MAJOR REPAIR AND ALTERATION (Airframe, Powerplant, Propeller, or Appliance)

1. Aircraft	Make Republic	Model RC-3
	Serial No. 1000	Nationality and Registration Mark N5166B
2. Owner	Name (As shown on registration certificate) Davey Darrell L Davey Deborah A	
	Address (As shown on registration certificate) 6613 Santa Rosa Rd Camarillo Ca 93012-5672

Republic RC-3 N5166B Ser.# 1000

2. Description: Modified elevator trim control by removing original trim control from top of cabin to instrument panel. Installed Cessna P/N 0510127-2 Wheel, tab control and Cessna P/N 0432134-1 Sprocket, tab control on .250" 303 stainless steel shaft with roll pins, Cessna P/N NAS561P3-4, mounted with Torrington bearings, Cessna P/N M-451 (2ea.), in brackets fabricated from .250" 6061 T6 aluminum plate and secured to instrument panel with MS24693C screws. Trim position indicator fabricated from 1/16" welding rod and attached to trim wheel position follower fabricated from .040 2024 T3 aluminum sheet. Position indicator is held in place with groove cut in avionics mounting support. Trim control cable, 1/16" stainless flexible control cable conforming to MIL-W-83420, is attached to trim control chain, Cessn

Additional Sheets Are Attached

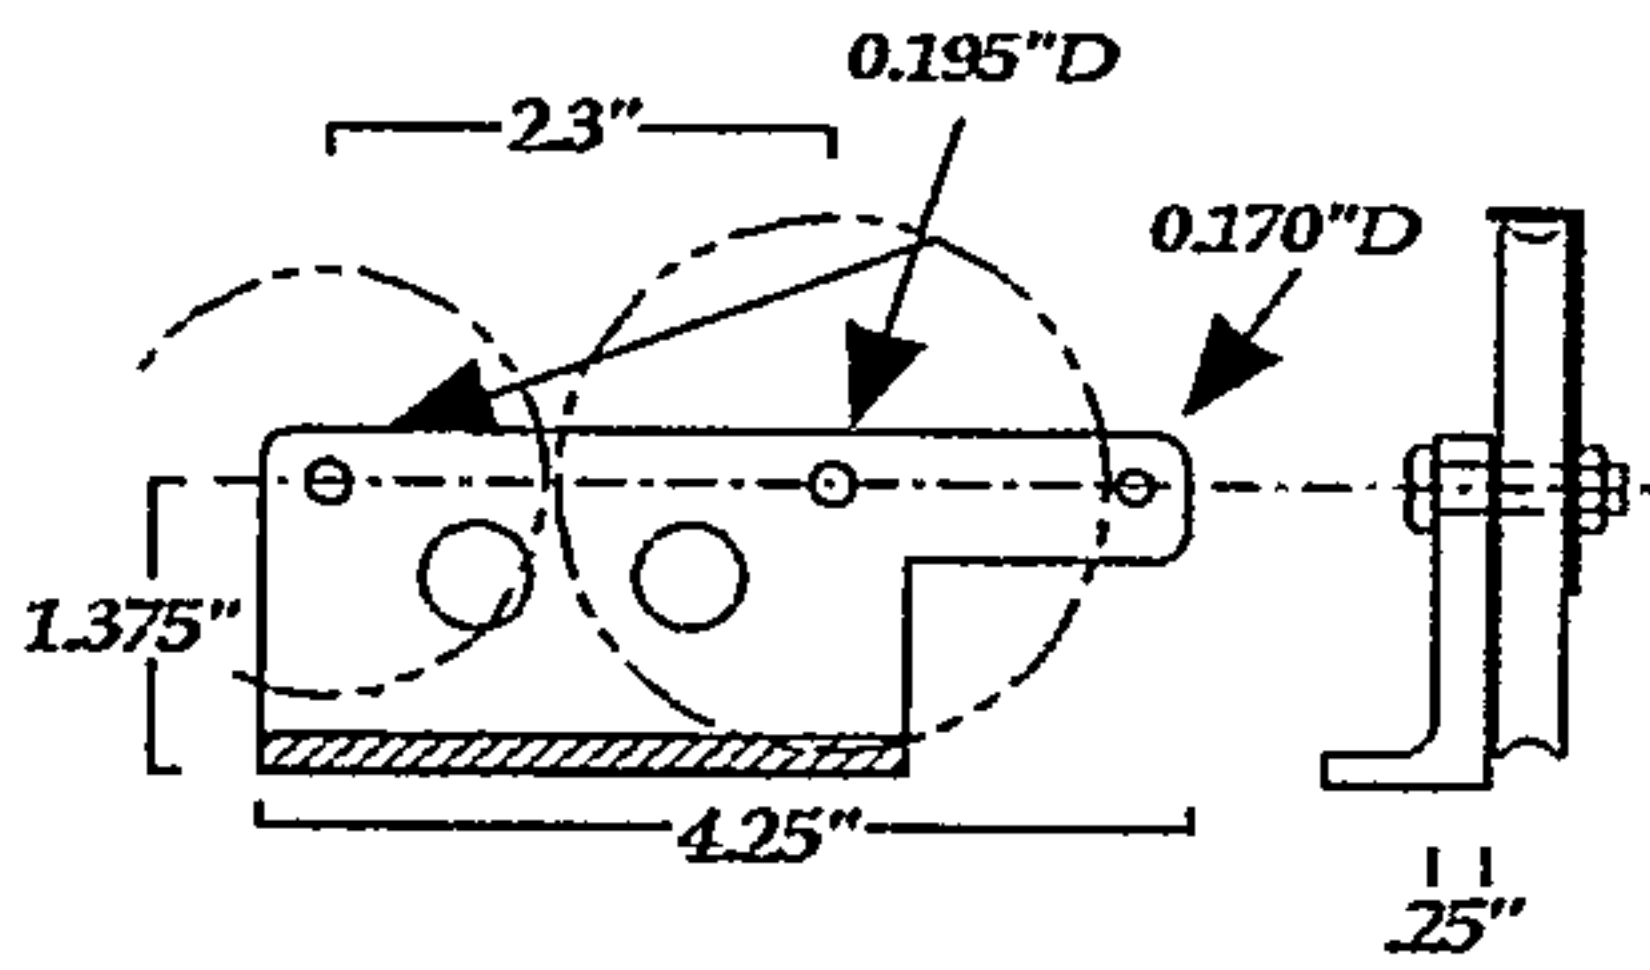
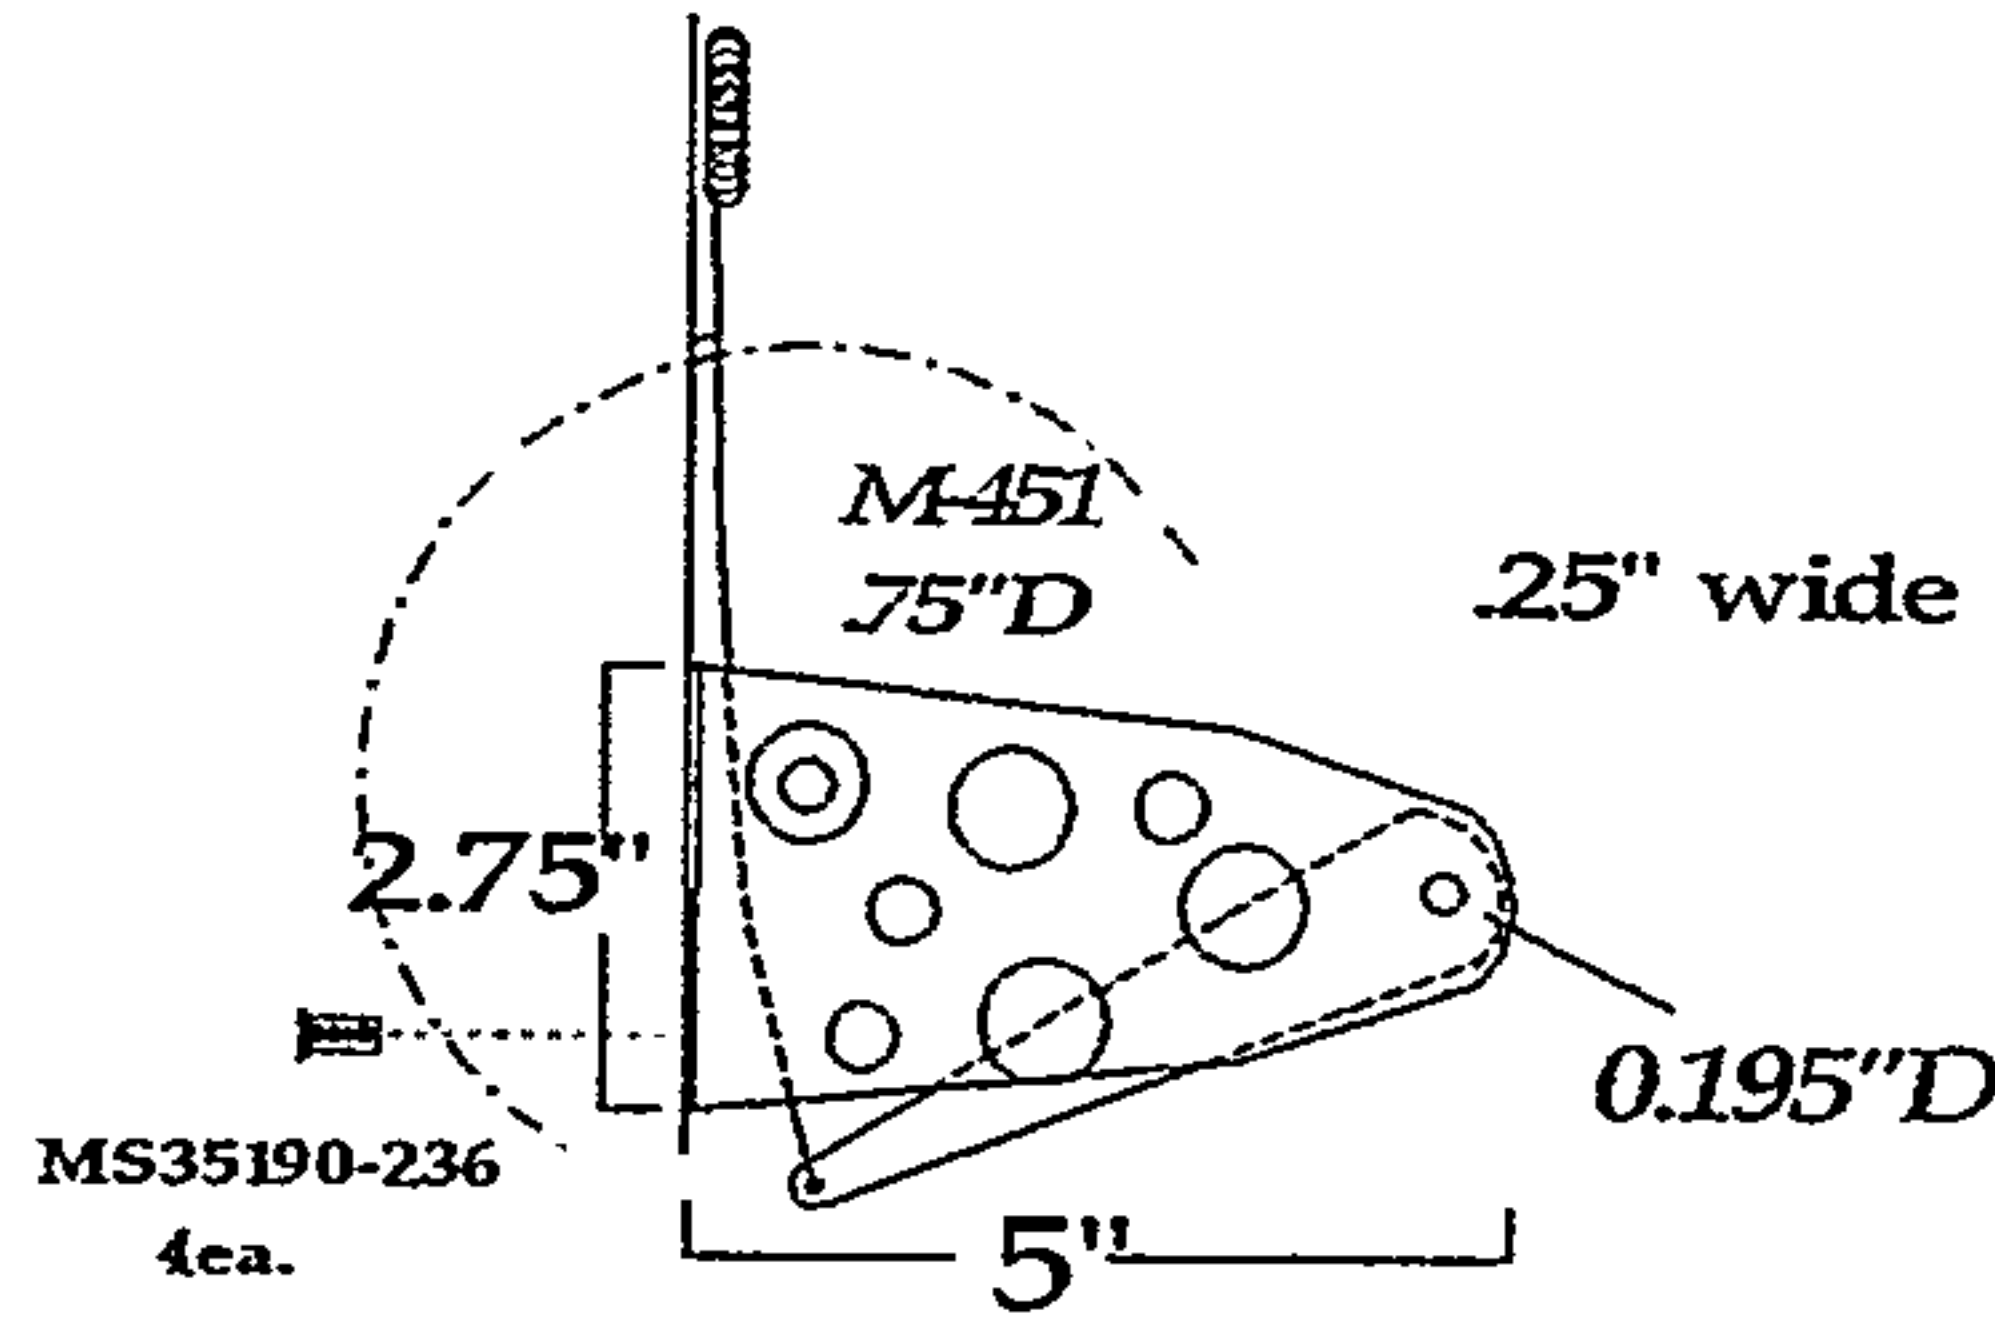
Blue - Original Routing of Trim Control
 Red - Modified Trim Control Routing
